DeKalb County Historic Preservation Commission

Staff Report

- A. 460 Princeton Way, J. Andrew and Colleen Doyle. Replace and expand driveway, install fence and gate in backyard, and construct a shed on rear of property. **1247656.**

Application for Certificate of Appropriateness

Figure 1. Proposed driveway replacement. Alterations from plan approved by DCHPC in 2009:

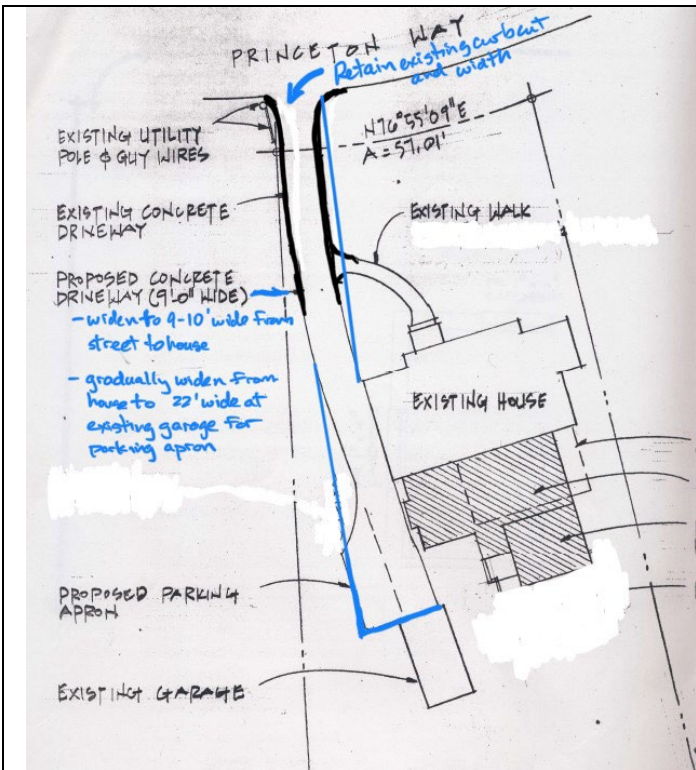
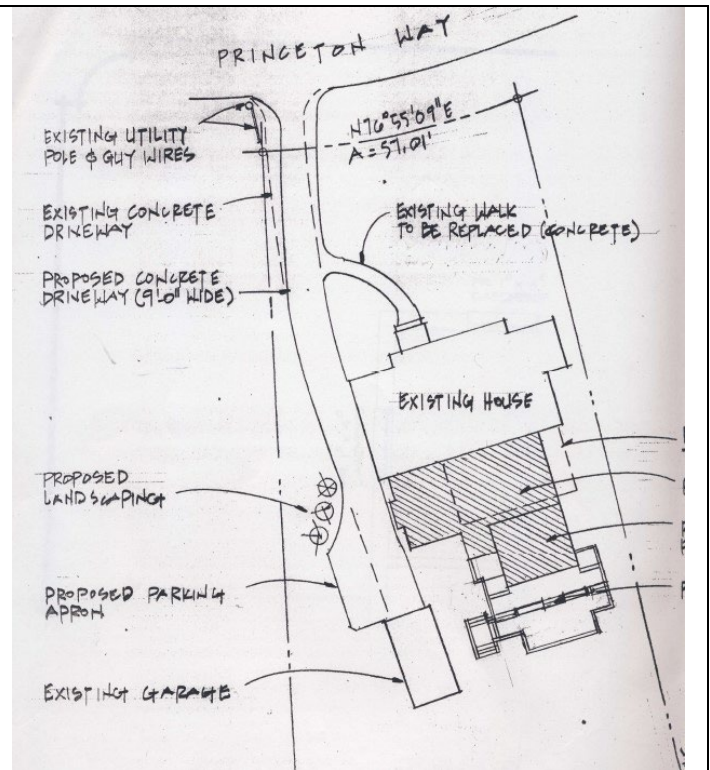
1. Will the driveway be replaced with concrete to match the existing driveway, or will a new material be used?

—> **Yes, the driveway will be replaced with concrete to match the existing driveway (not new material).**

Figure 11. Proposed installation of 4-foot chain link fence along south and west property lines similar to the existing fence on the east property line. Alterations from plan approved by DCHPC in 2009:

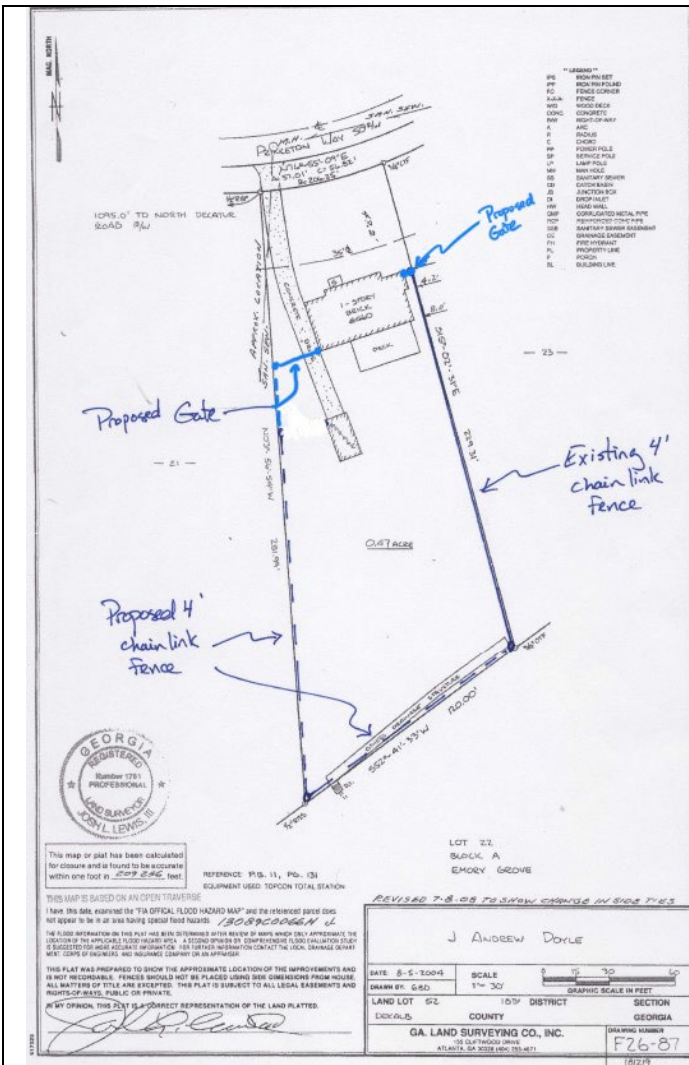
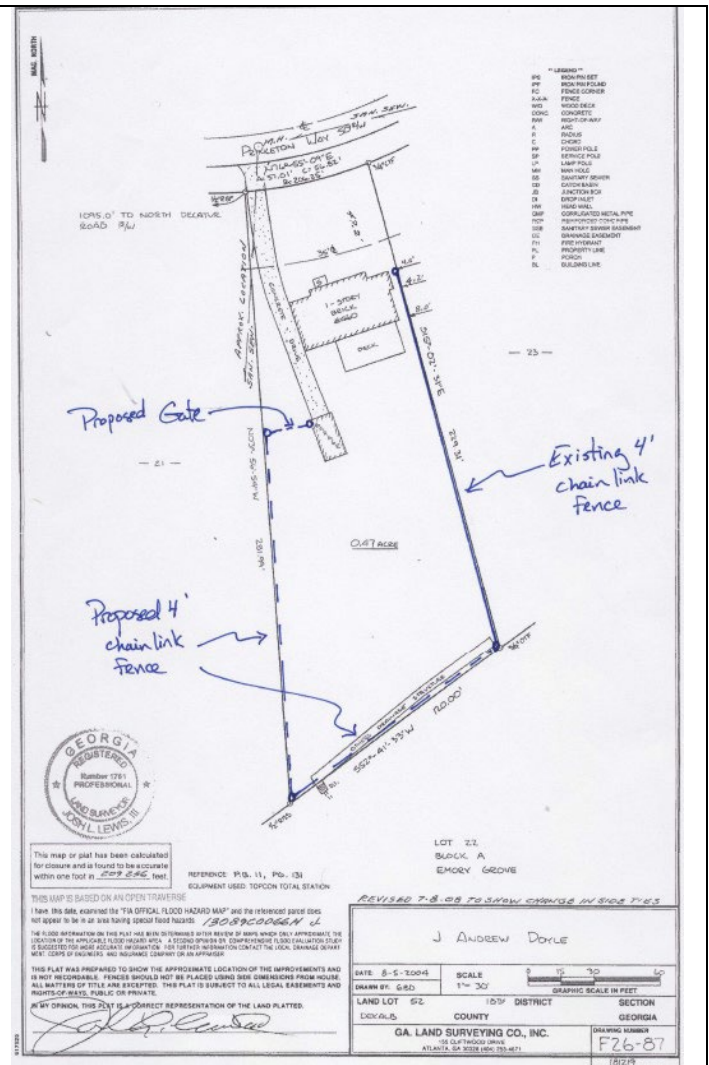
2. What is the proposed material for the two side gates? Will the gates match the fencing height of 4'?

—> **The two side gates will be chain link - height and material to match the existing 4' chain link fence on the east property line.**
